Volvo Chassis - Field Service Bulletin - FSB 293-027 EGR Mass Flow Rate Low - (SPN 2659 FMI 18 Or P0401)

FSB 293-027, EGR Mass Flow Rate Low

(January 2015)

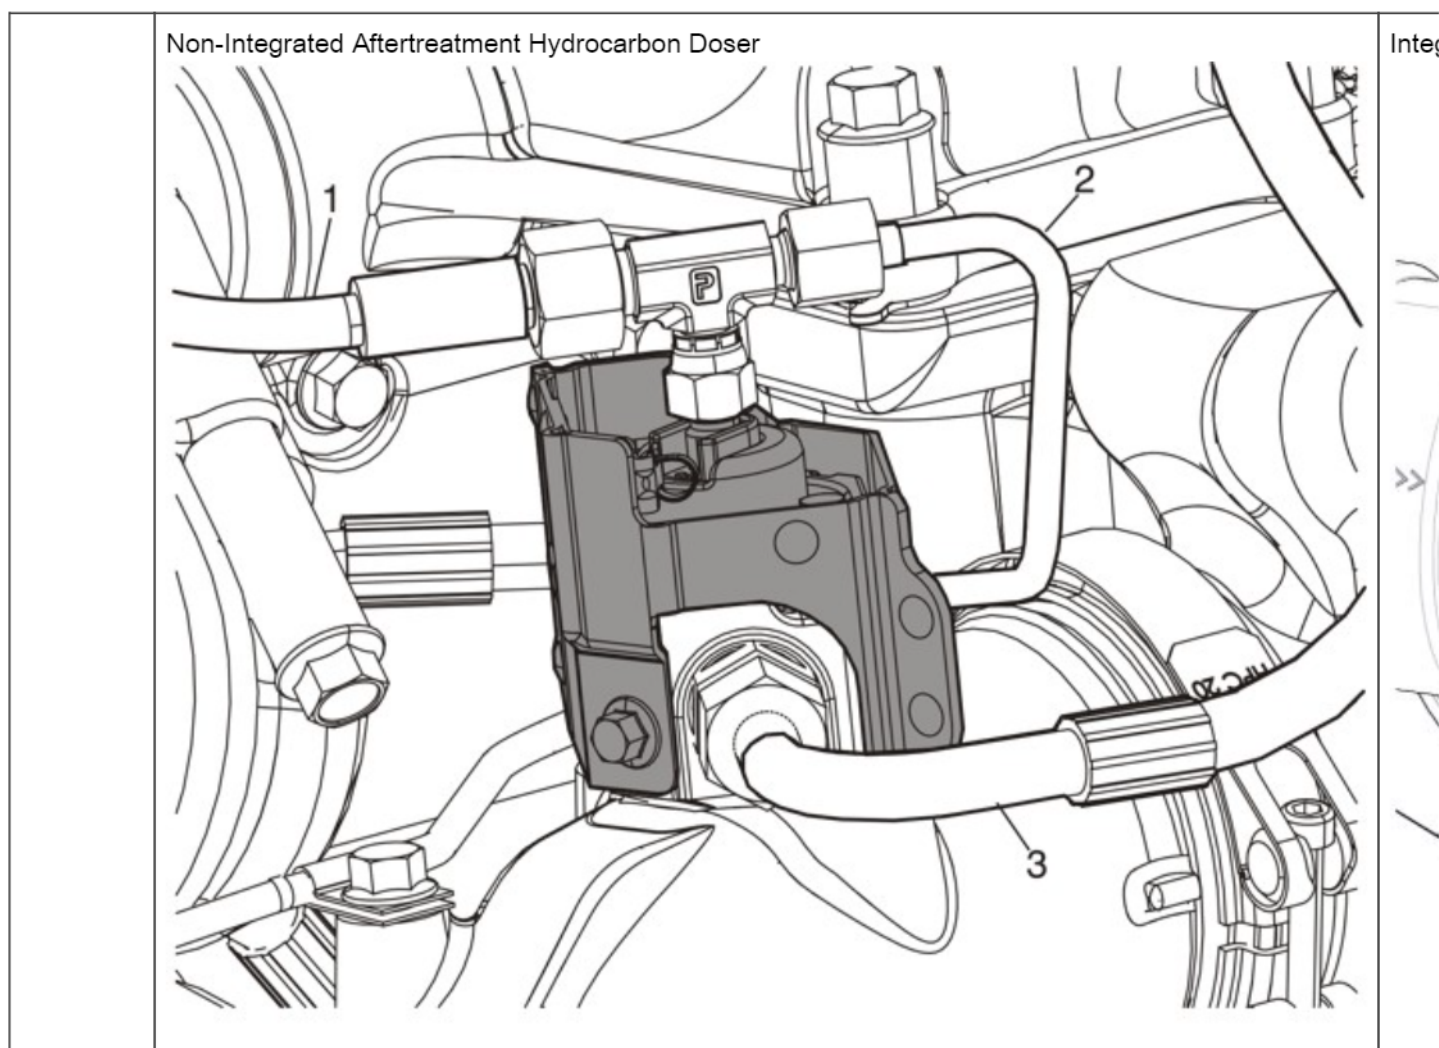
This bulletin is released to address high counts of diagnostic trouble code (DTC) SPN 2659 FMI 18 or P0401 only during normal to high load driving conditions on vehicles assembled between January 2010 and December 2013.

It has been determined that deposits in the EGR cooler can build up and cause high restriction over time. This high restriction prevents the required amount of EGR gas from flowing through the EGR cooler creating DTC SPN 2659 FMI 18 or P0401 EGR Mass Flow Rate Low to be logged intermittently. Normally, this is only reported on higher mileage vehicles.

- Use PTT to determine engine main software level and compare to applicable chart below. If engine main software is equal to or greater than the applicable software levels shown in the table below, no programming is required. If engine main software is below the levels shown, engine ECM programming is required.
- Replace the EGR cooler.
- Clear inactive DTC after all repairs are completed.
